**FOR
LAMAR STATE COLLEGE-PORT ARTHUR
PORT ARTHUR, TEXAS**

**RUBY FULLER EDUCATION
BUILDING**

758-20-04013

ADDENDUM #2

SHEET NUMBER
A1.1
19-148
PROJECT NO.

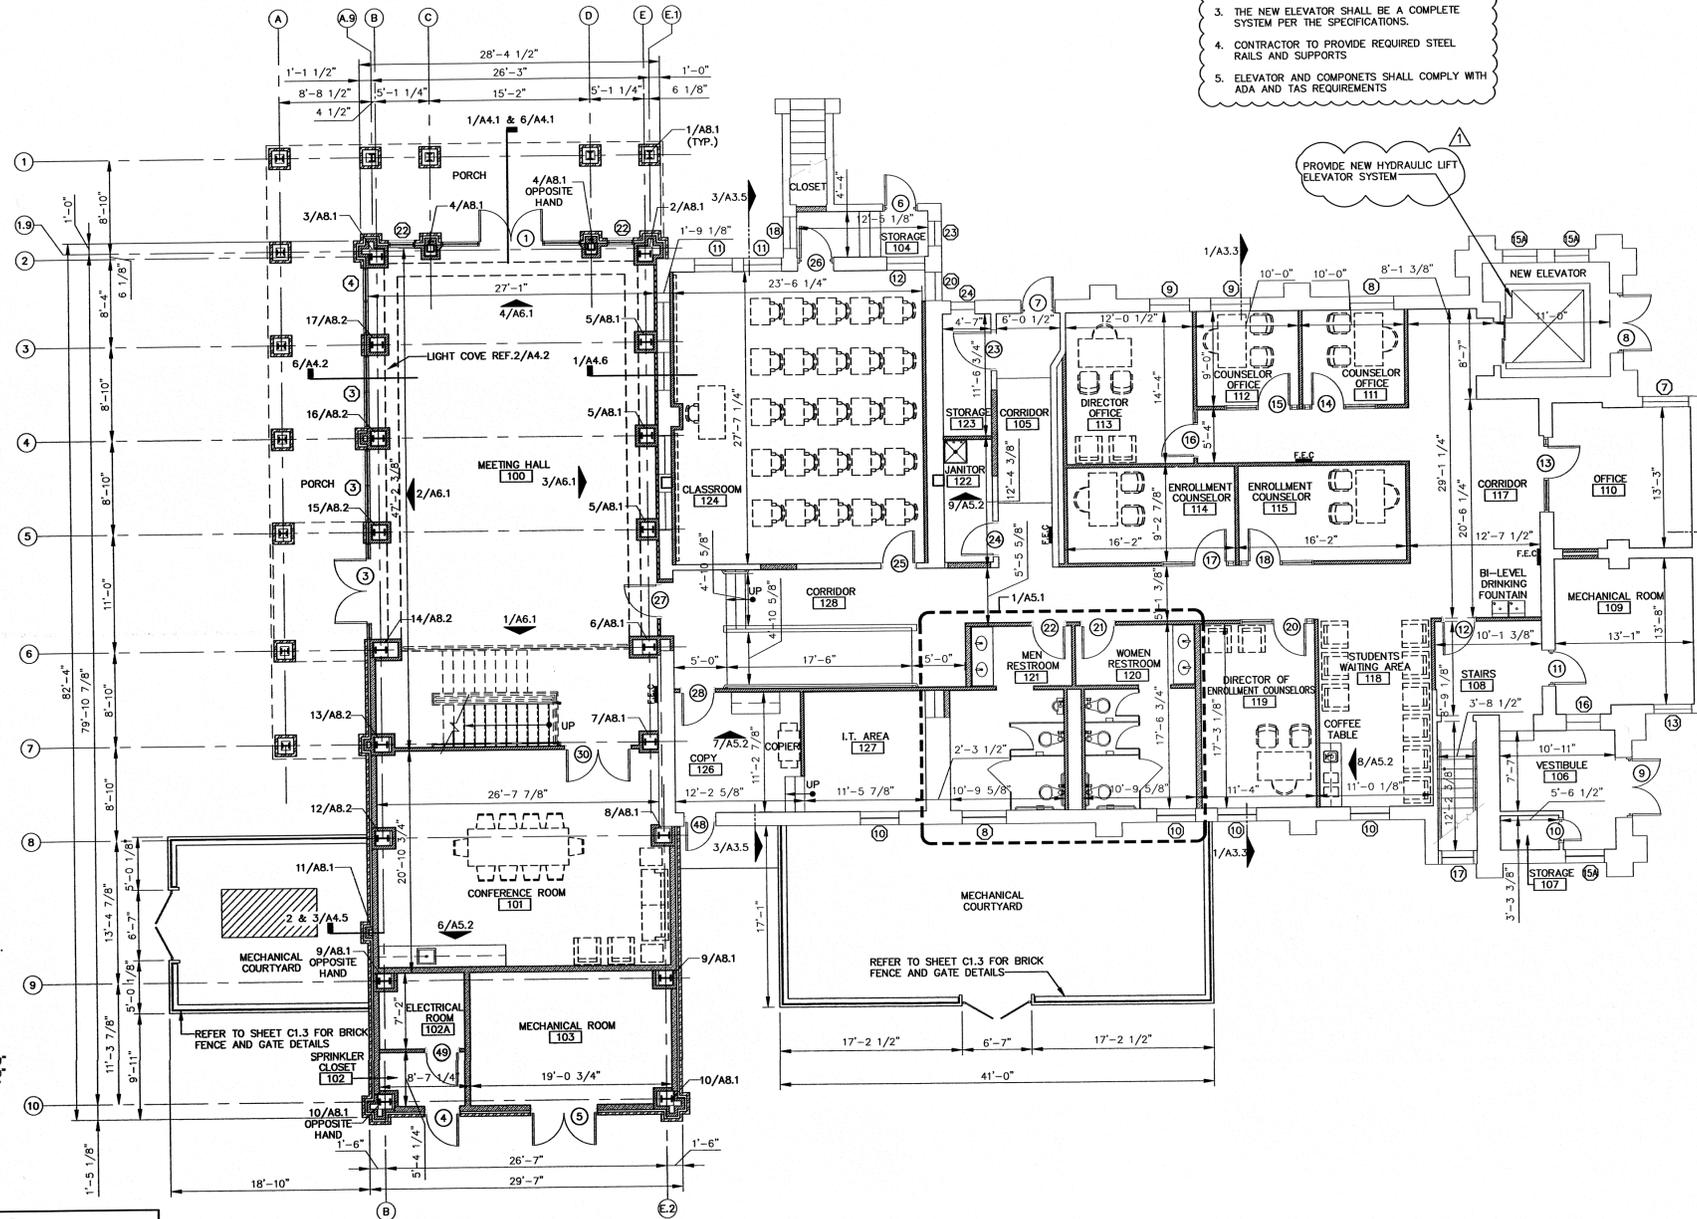
Answer: See reply to Number B.4.
22. **Question:** Refer to drawing A1.1. The Legend calls out for all metal studs but they should be wood studs on the first floor to support the floor joists and decking of the 2nd floor per the structural drawings. The line quality on my drawings is not very clear so it’s hard to determine wood studs from metal studs. Please clarify the stud types at all locations of the 1st and 2nd floors.

Answer: The Contractor shall use wood studs per sheet S2.1 for the bearing walls and the 2nd floor framing.

SHEET NUMBER
A6.1

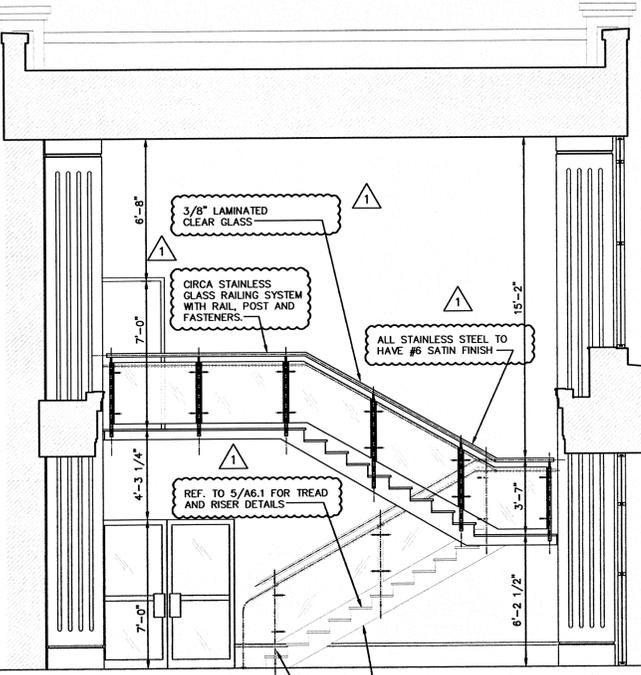
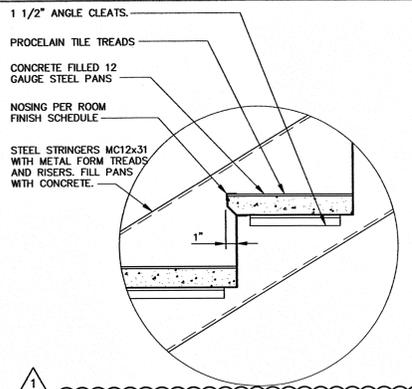
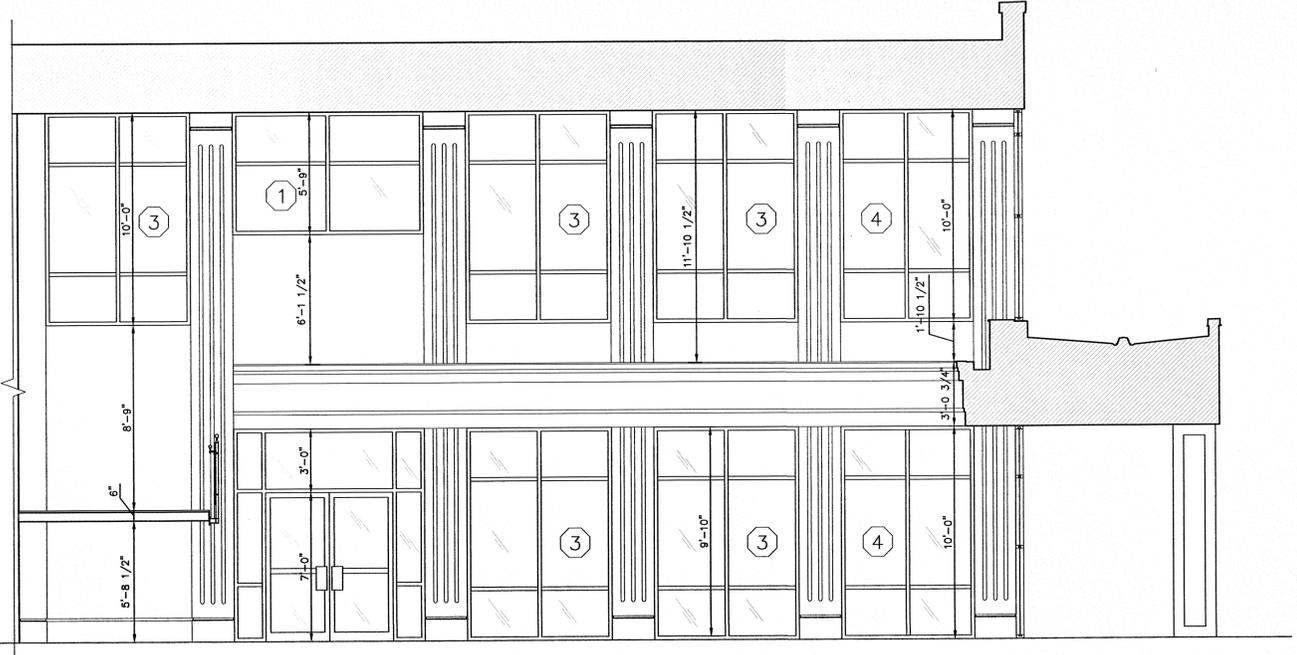
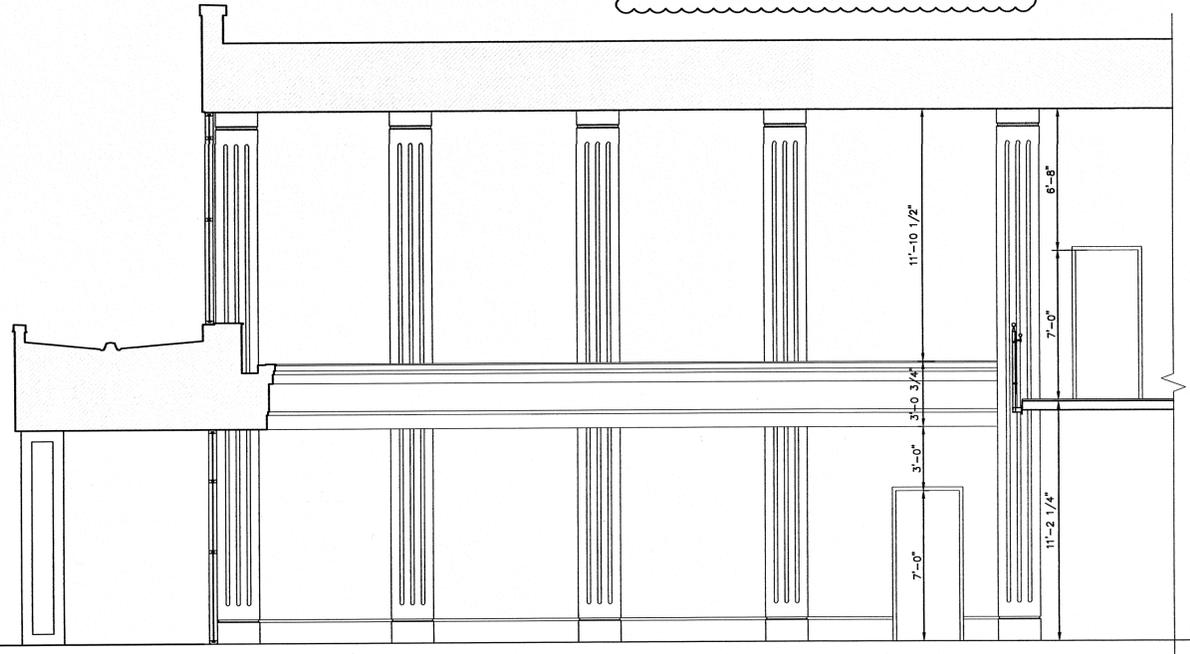
11. **Question:** Sheet A6.1 detail 1 shows prefabricated stair by pacific stair corporation which may differ per section 05500. Please advise with spec if necessary?

Answer: See attached Prefabricated Stair Specification Section 05 51 00.
12. **Question:** Sheet A6.3 detail 1 shows fixed aluminum ladder by precision ladders? Is there a spec on this?

21 PLAN DETAIL
SCALE: 1" = 1'-0"

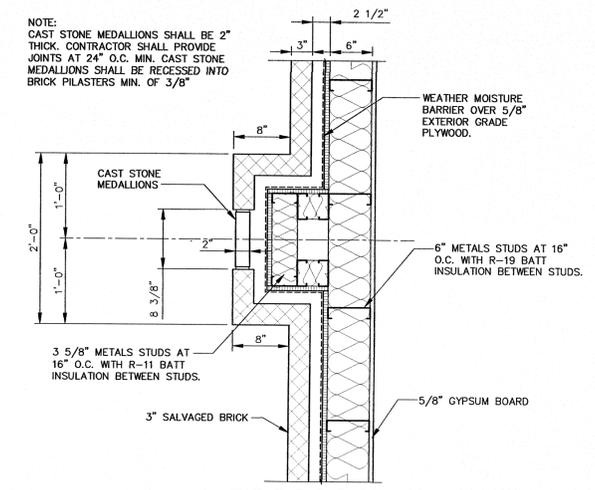
Answer: The new modified bitumen roof on both towers will be installed on exiting wood deck.
24. **Question:** Refer to drawing A3.2 ALT. There are cast stone medallions called out at the brick pilasters. There are no sections or details shown on the drawings. Please clarify.

Answer: Cast Stone Medallions shall be min. 2" thick. Contractor shall provide joints at 24" O.C. min. Cast Stone Medallions shall be recessed into brick pilasters min. 3/8". See enclosed revision to sheet A8.2 detail 21 for details.

NOTE:
CAST STONE MEDALLIONS SHALL BE 2" THICK. CONTRACTOR SHALL PROVIDE JOINTS AT 24" O.C. MIN. CAST STONE MEDALLIONS SHALL BE RECESSED INTO BRICK PILASTERS MIN. OF 3/8"

SHEET NUMBER
S2.5

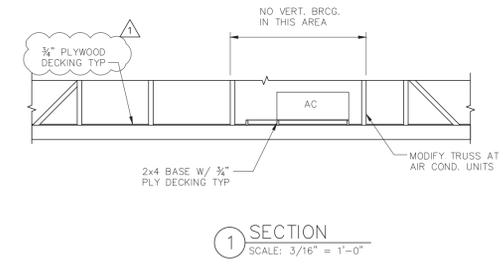
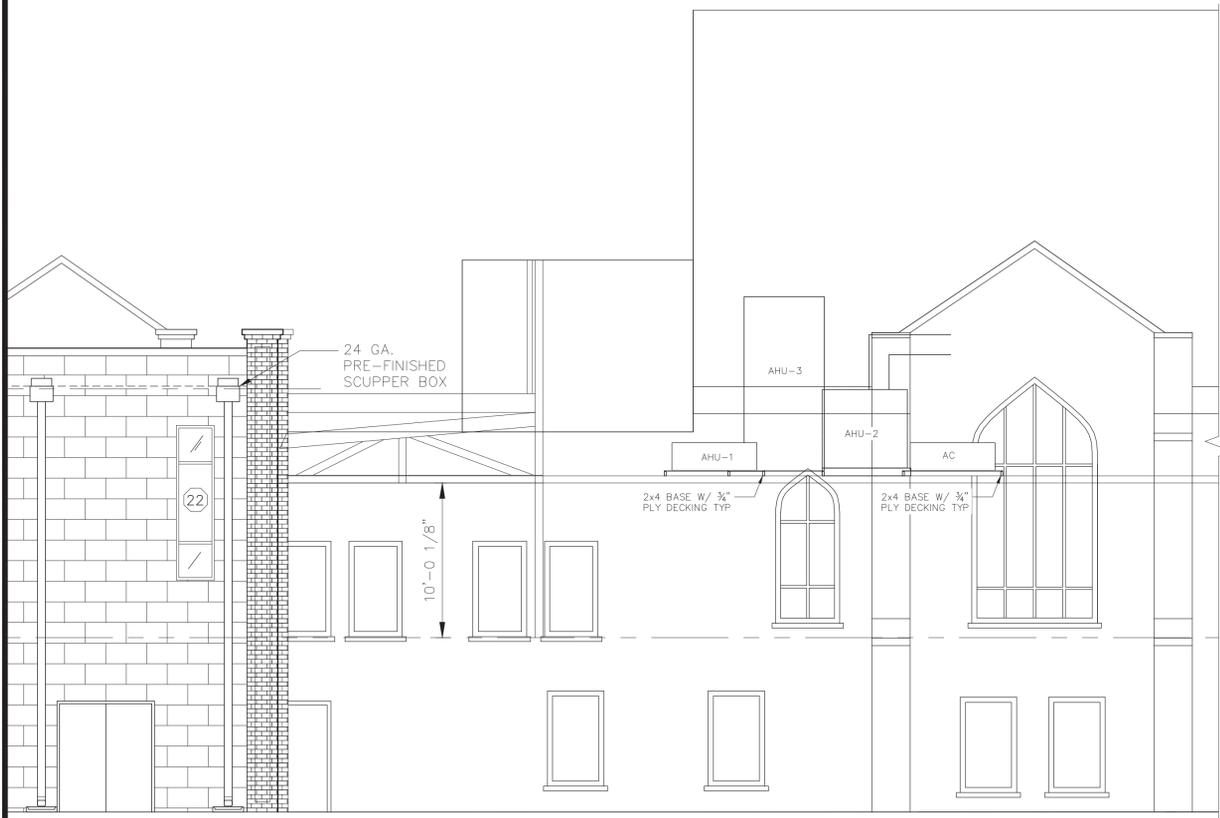
32. **Question:** Refer to the HVAC Platform Plan on drawing S2.5. There appears to be a plywood landing platform (decking) around the hatch to access the AHU's but it's not continuous the full area of the platform. It seems like the entire platform should be decked for access to the units. Am I looking at this correctly?

(ATTACHMENT #M4a)

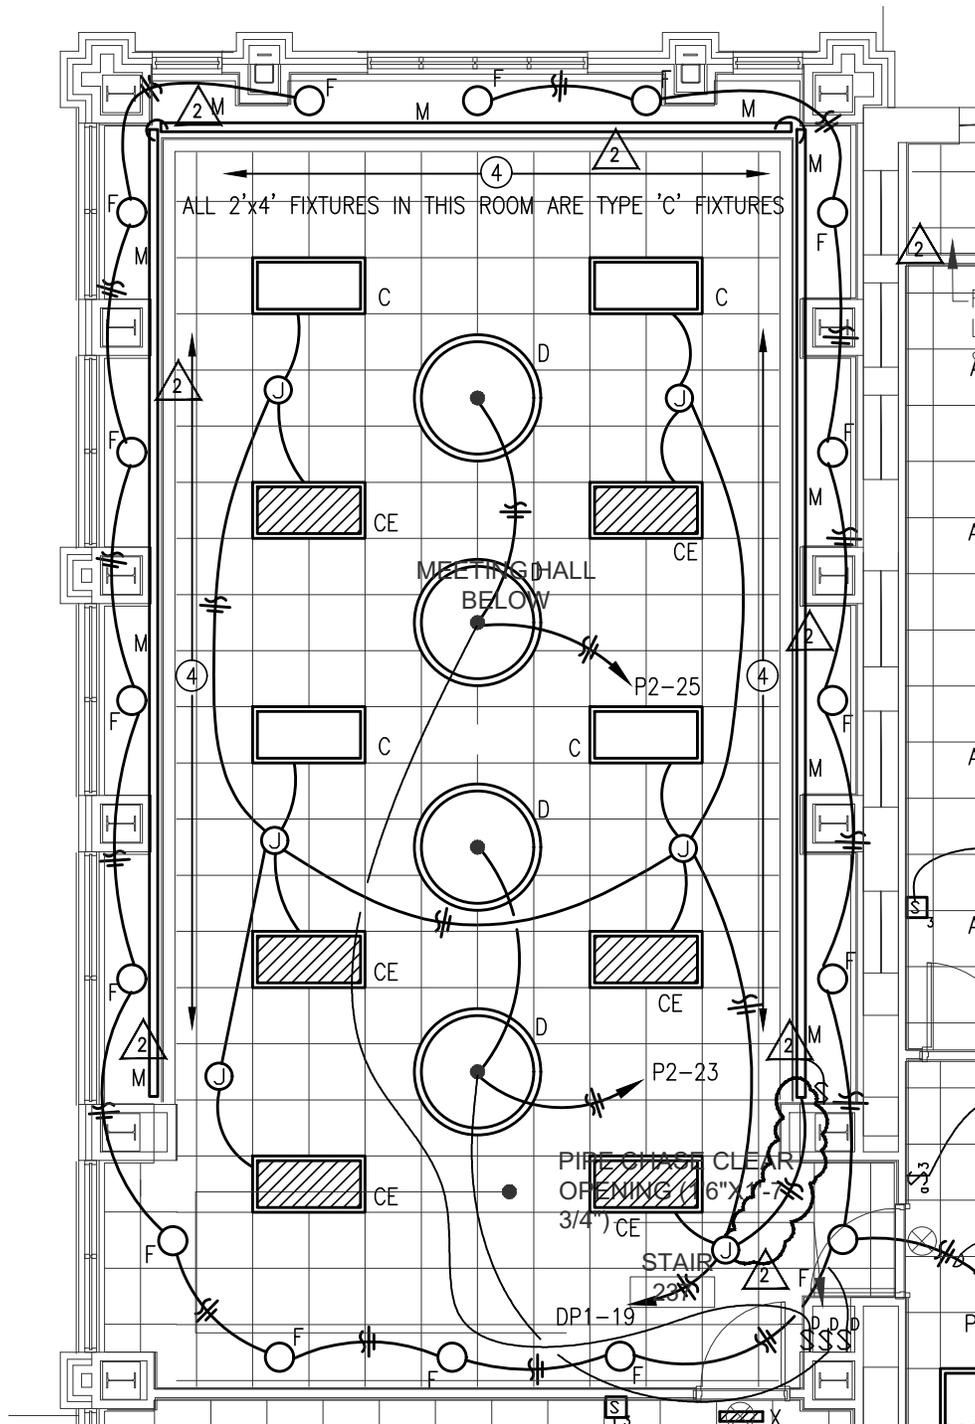
3. Per Sheet M-2 Add general note U to read: Contractor shall provide ¼” scale shop drawings for review and approval before fabricating ductwork.
4. See Attachment M4a “Coil Piping 3-way “detail for reheat coils.

2. Add to Air Device schedule Type F louver, GreenHeck ESU-154 thin-line stationary louver, or equivalent.
- E. Mechanical Drawing M-4:**
1. See Attachment M4a (in Addendum 2) “Coil Piping 3-way” detail for reheat coils.

(ATTACHMENT #E2.1a)

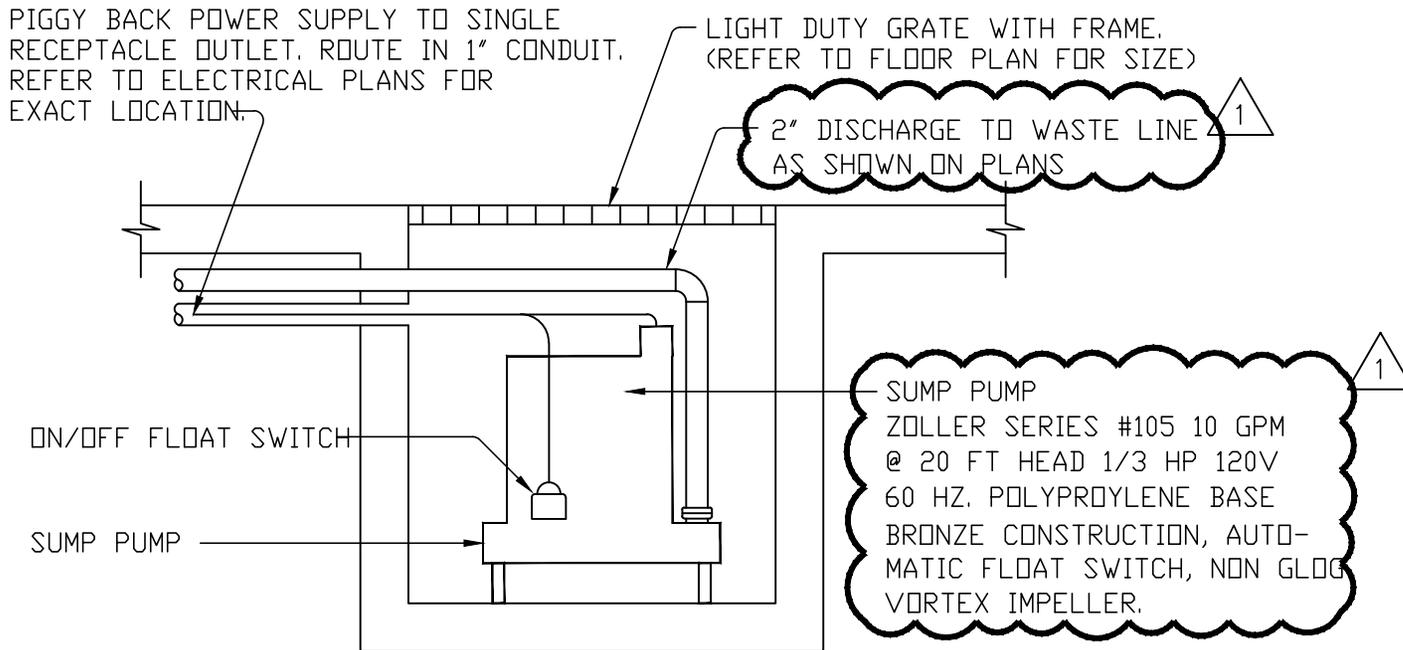
Answer: See reply to Number C.8.
20. **Question:** Refer to 2/A4.2. I don’t see where the LED light fixture in the Light Cove is scheduled on the Lighting drawings E-2.1. And the Lighting Plan on E-2.1 shows a fixture or outline of a fixture over the Monumental stair that doesn’t match the reflected ceiling plan. Please clarify.

- ④ PROVIDE CONTINUOUS ROW OF TYPE 'M' LIGHT FIXTURES FOR COVE LIGHTING. SEE ARCHITECTURAL SECTION 2/A4.2

- I. Electrical Drawing E-2.1:**
1. See the partial plan Attachment E2.1a (in Addendum 2) for changes and additions to lighting in Meeting Hall 100.
 2. In Open Gathering 231 the light fixture there shall be a Type “L” under counter fixture not a can light. Wire fixture to circuit P2-29 with Type B fixture.
